File No: 2019/572869

Your Ref: MP 06_0171 MOD 16 & SSD-9374

Request for advice – Modification of Central Park Concept Plan (MP 06_0171 MOD 16) and Block 4B Central Park Adaptive Reuse (SSD-9374)

Figure 1 Options to consider for through-site link

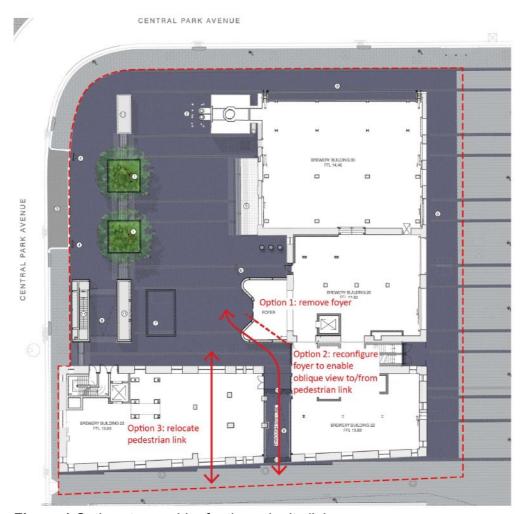
The combination of the new foyer and the location of the through site link results in a pedestrian connection that lacks a clear view into or from the central square. A direct visual connection from one space to another is critical in the success and safety of this pedestrian route. It is recommended one of the following amendments be made to the layout to resolve this issue:

- Remove the new foyer addition to 'un-block' the view.
- Reconfigure the foyer to remove the southern protrusion, and enable a direct but oblique view of the through site link from the square.
- Reposition the through site link to the adjacent carriageway bay (to the west), enabling both the retention of the foyer and a clear view through the pedestrian connection.
